Petition for Modification No. 1

Minor Equipment Location Changes

Walnut Creek Energy Park

October 2008

FIGURE 2.1-1A
Revised EME Walnut Creek
Energy Park General Arrangement
 Walnut Creek Energy Park Modification 1
 Walnut Creek, California

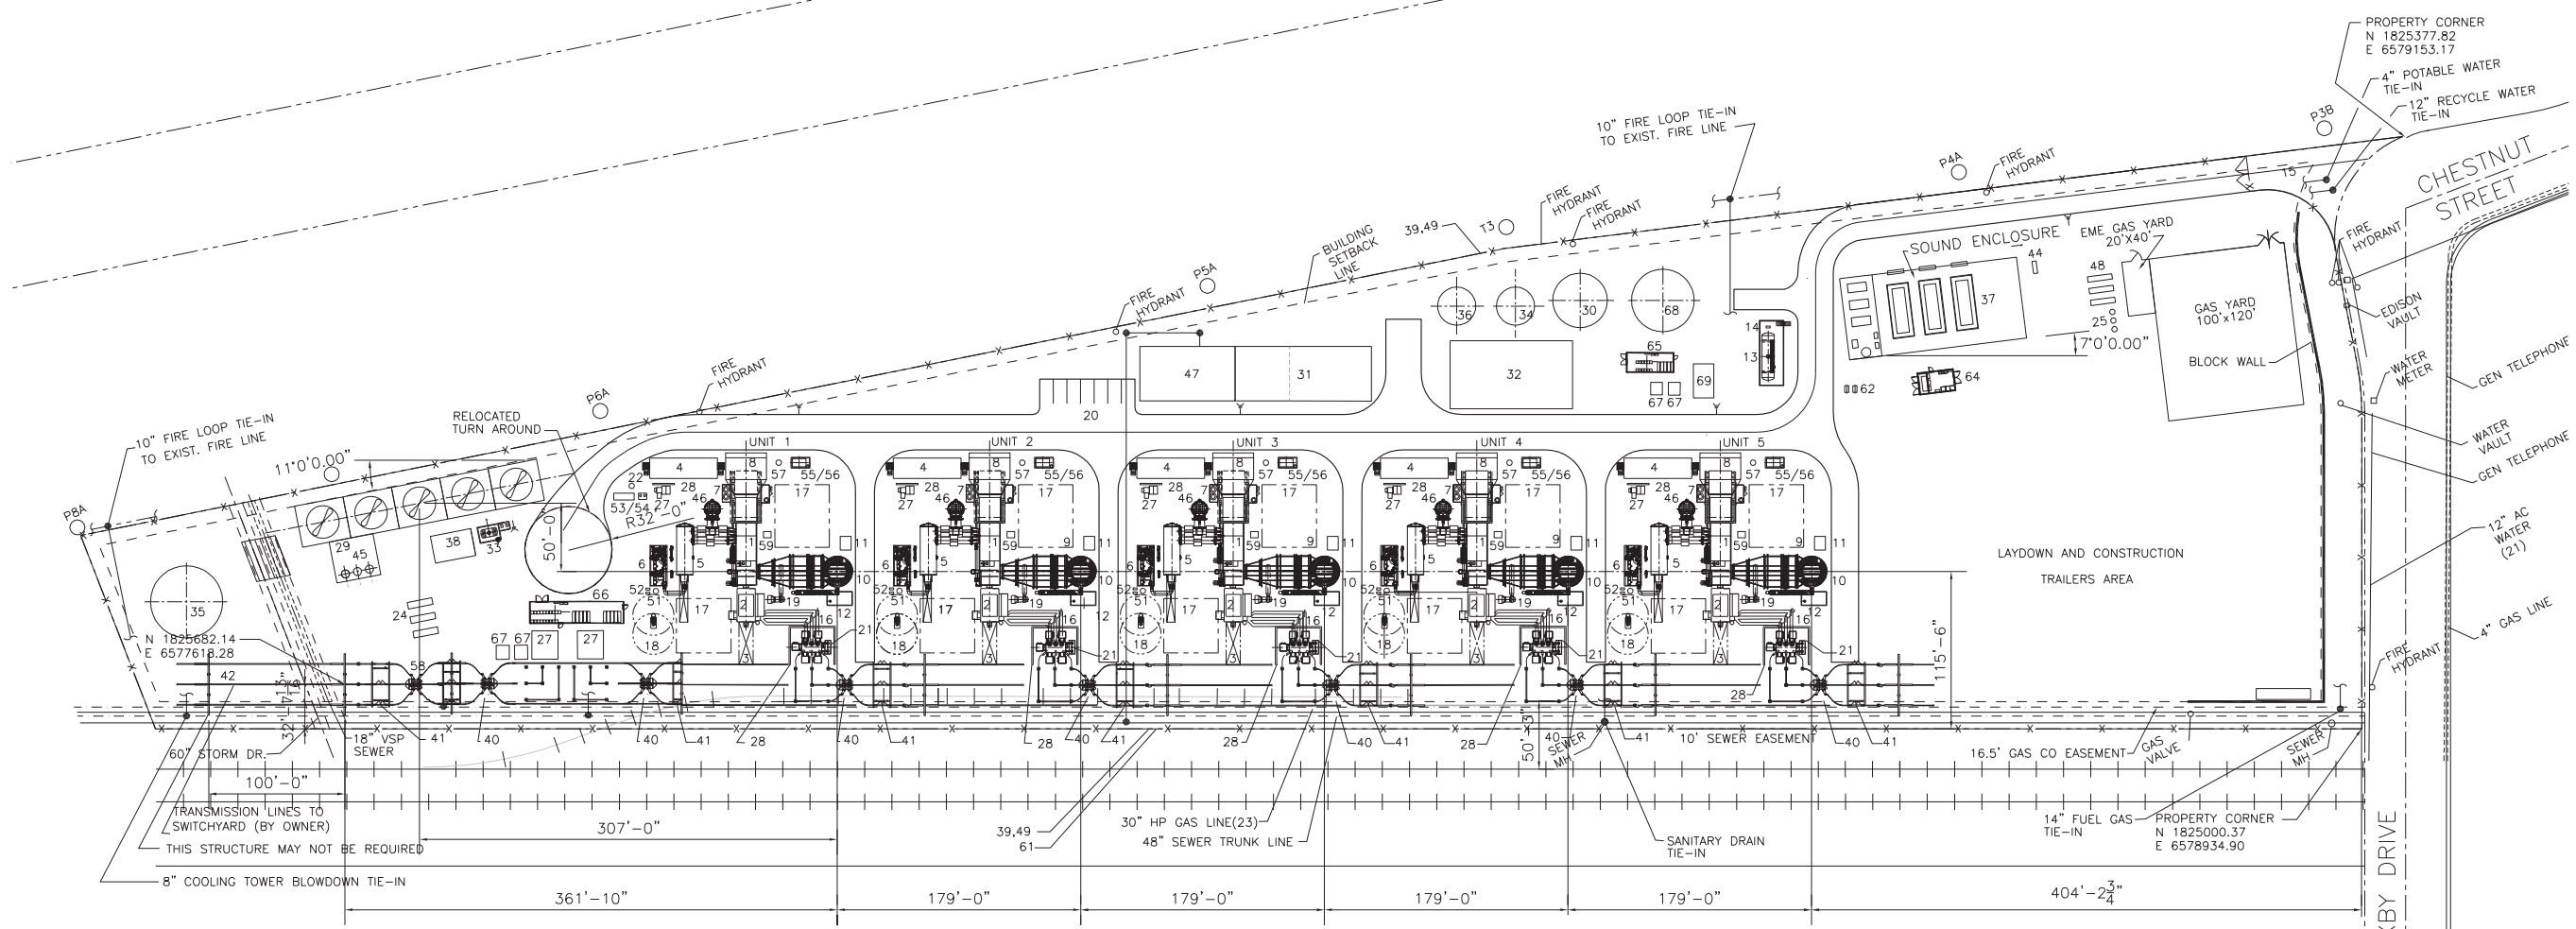
- Per direction from the Los Angeles County Fire Department, a turnaround circle will be added to the end of the facility driveway at the northern end of the site. To make room for the turnaround circle, the gas compressor building (37) will be moved from the western end of the project site, near the power distribution center (66), to the eastern end of the project site.

- A gas metering yard and filters will be located adjacent to the gas company yard on the east end of the project site.
- The cooling tower (29) will be moved approximately 120 feet east of the location identified in the AFC.

- The wastewater storage tank (35) will be added to the far west end of the site. The tank will be located near the cooling tower location.
- The control building and the warehouse/maintenance building will be combined into one building (47 and 31).

- The recycled chlorination tank will be removed.
- Miscellaneous small equipment will be added (51 to 68).
- Five high-side electrical breakers (40) will be added along the southwest side of the site.

FIGURE 2.1-1B
Comparison of the Proposed EME Walnut Creek Energy Park (WCEP) General Arrangement to the EME WCEP AFC General Arrangement
Walnut Creek Energy Park Modification 1
Walnut Creek, California

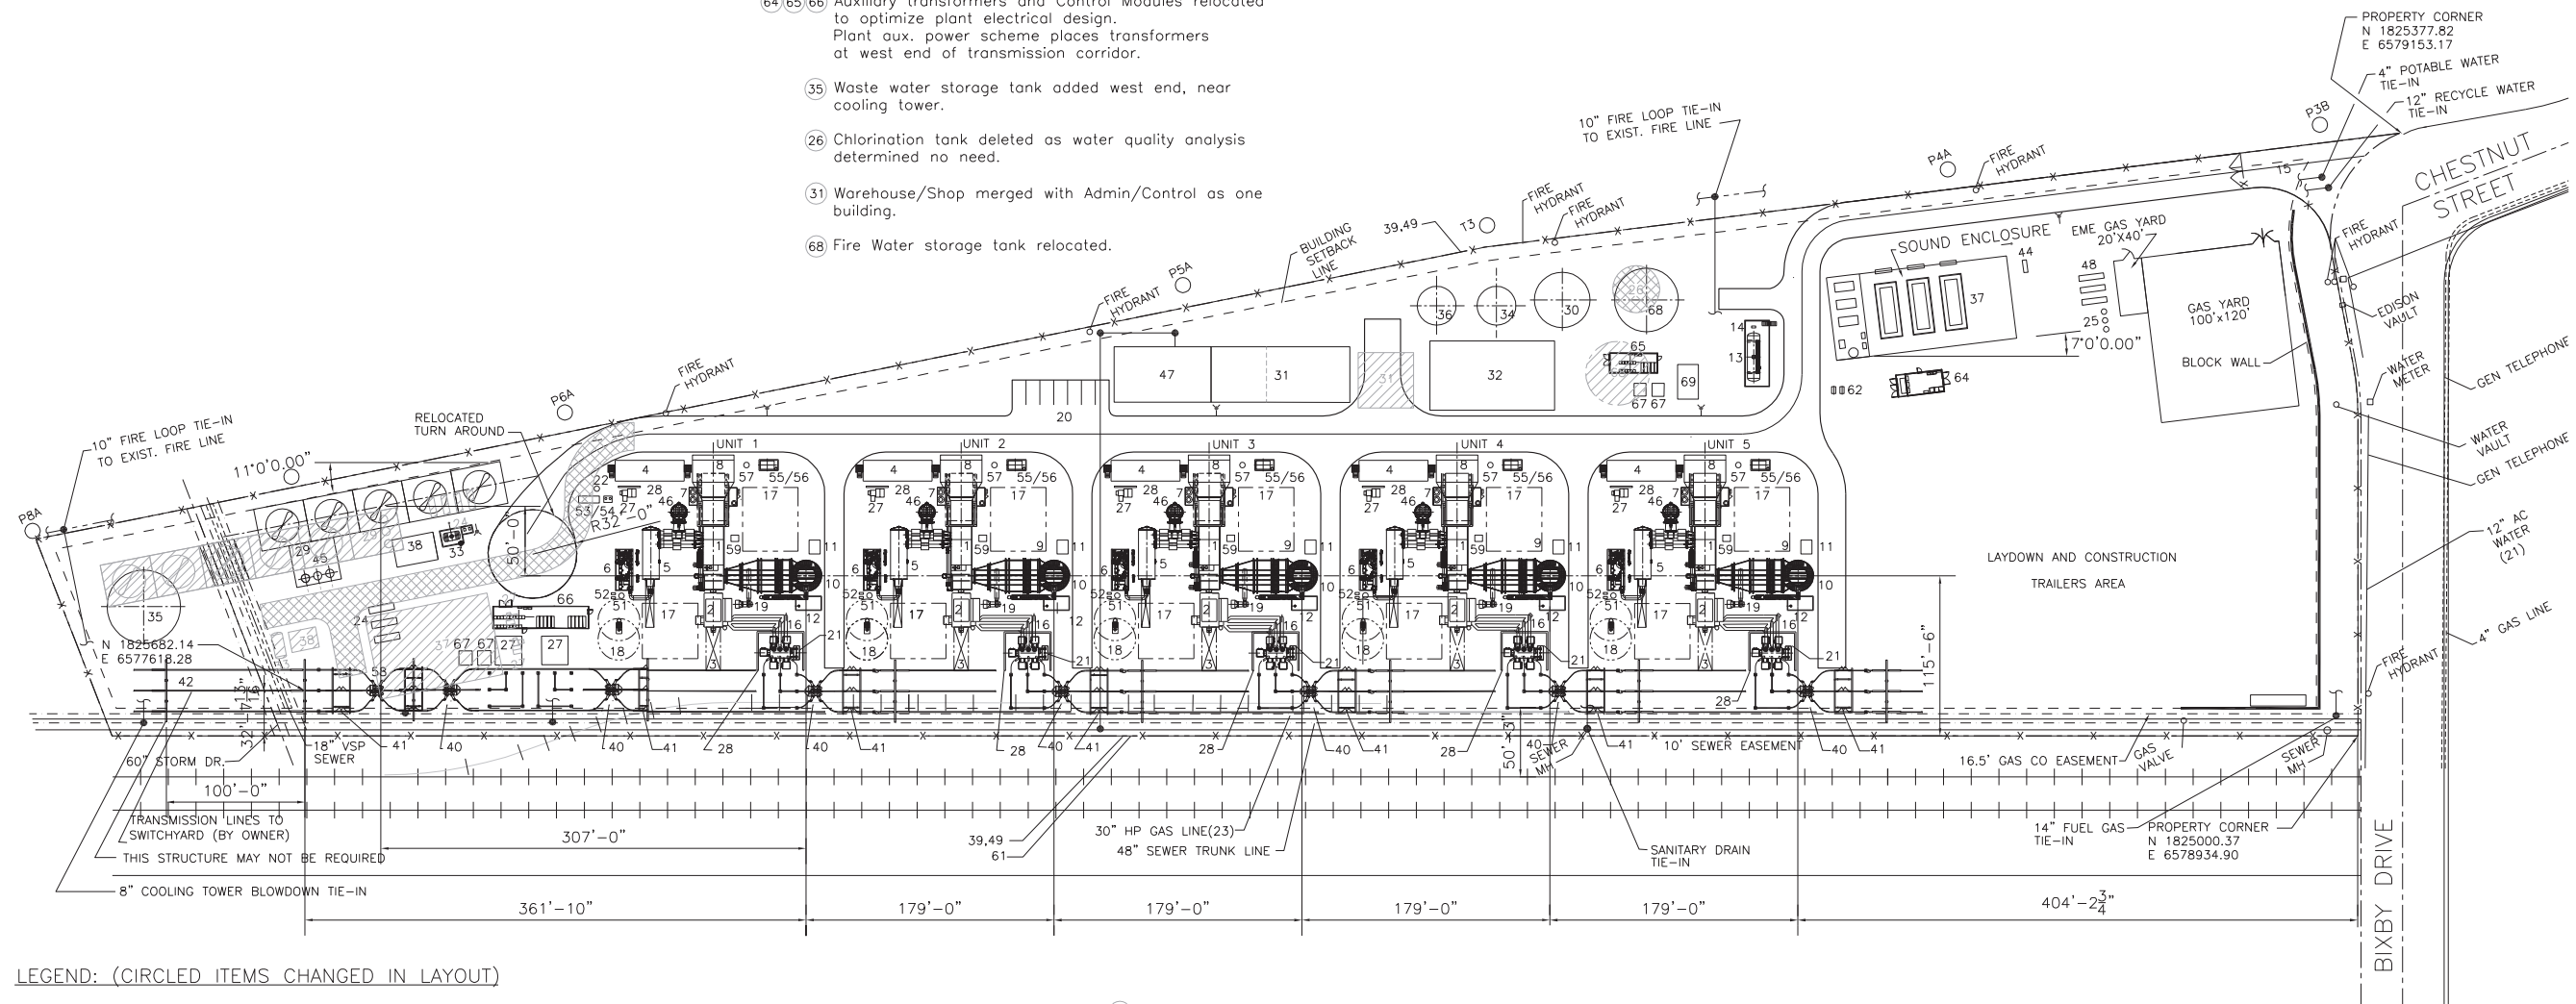
- Roadway revised at west end to allow space for equipment relocation and provide traffic turn-around.
- (24) (29) (38) (45) Cooling tower shifted east, off existing underground pipe corridor, pump basin placed on long side.
- (25) (37) (48) Natural Gas equipment and enclosure relocated east and north.
- (64) (65) (66) Auxiliary transformers and Control Modules relocated to optimize plant electrical design. Plant aux. power scheme places transformers at west end of transmission corridor.
- (35) Waste water storage tank added west end, near cooling tower.
- (26) Chlorination tank deleted as water quality analysis determined no need.
- (31) Warehouse/Shop merged with Admin/Control as one building.
- (68) Fire Water storage tank relocated.

FIGURE 2.1-2
Revised EME Walnut Creek Energy Park
Elevation Drawing
 Walnut Creek Energy Park Modification 1
 Walnut Creek, California

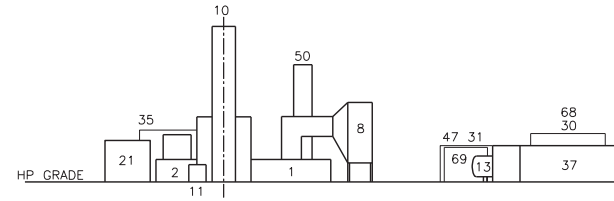
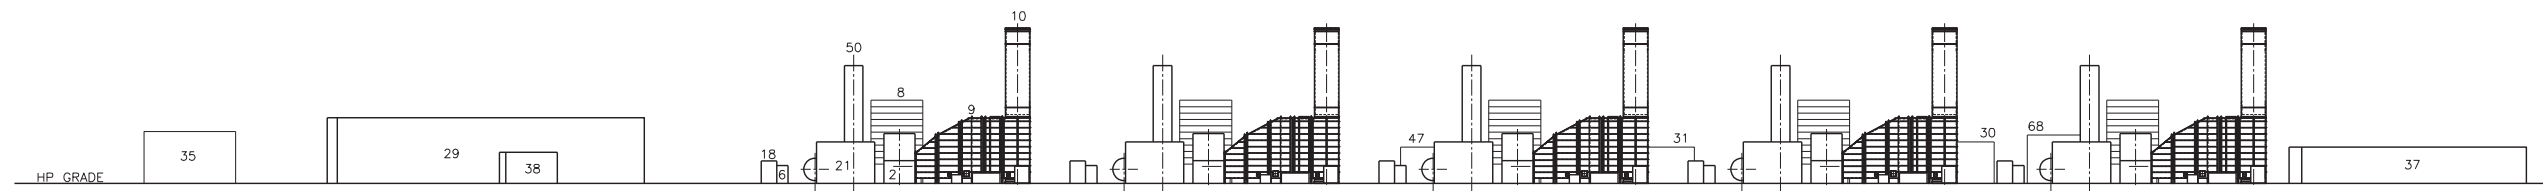
This section includes a description of the proposed project modifications, consistent with CEC Siting Regulations (Title 20, CCR, Section 1769 [a][1][A]). Walnut Creek Energy, LLC proposes to modify the previous project layout to accommodate the development of the project and optimize the arrangement of the facility equipment. Figure 2.1-1a presents the revised general arrangement drawing. Figure 2.1-1b presents a comparison of the proposed modifications to the general arrangement drawing included in the AFC. Figure 2.1-2 shows the profile view (elevation) of the project design, as revised.

FIGURE 3.1-1
Revised ISCST3 Building Location Plot

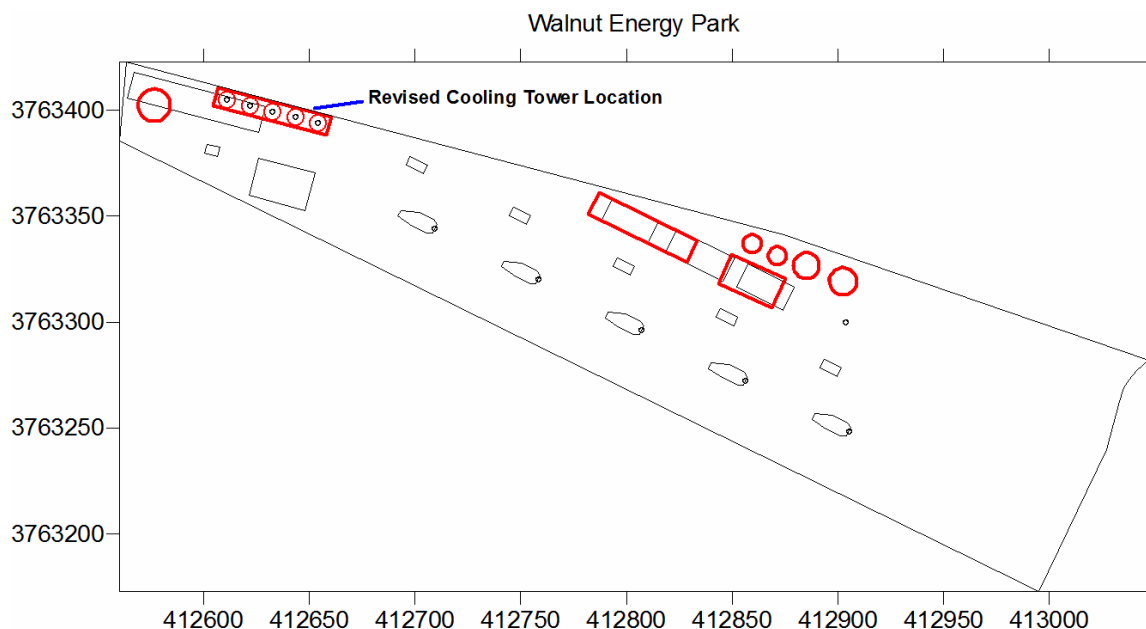
WCE proposes to move the WCEP cooling tower approximately 120 feet to the east, which would place it closer to the LMS-100 turbines. To assess the potential for changes to the project air quality and health risk impacts, the new cooling tower location was analyzed with both the Industrial Source Complex Short Term Model (ISCST3) as well as the Hotspot Analysis Reporting Program (HARP). As part of the inputs into both models, the Building Profile Input Program (BPIP) was also used to calculate the revised structure dimensions based on the new location of the cooling tower. No other changes to emissions or source locations are proposed for the WCEP. The revised cooling tower location used in the ISCST3 dispersion modeling analysis is depicted in Figure 3.1-1.

In order to determine the potential for a revised magnitude and location of the maximum impacts for each pollutant and averaging period, the ISCST3 model was used to directly compare the potential for changes. Based on output from BPIP, the revised cooling tower location will have minimal effect on the turbine's air quality impacts. Table 3.1-1 summarizes maximum-modeled concentrations for each criteria pollutant and associated averaging periods. The results of the modeling analysis demonstrate that the 1-hour and 8-hour carbon monoxide (CO) concentrations, as well as the annual nitrogen dioxide (NO₂) concentrations, would decrease with the proposed project modification. All other pollutants and averaging times would have the same impact as previously modeled in the AFC. Similarly, the turbine startup and commissioning activities would result in no changes to the modeled concentrations. Thus, for air quality impacts, no significant changes in air emissions impacts are expected to occur as a result of the change in the cooling tower location. A compact disc containing the modeling input/output files will be submitted under separate cover.
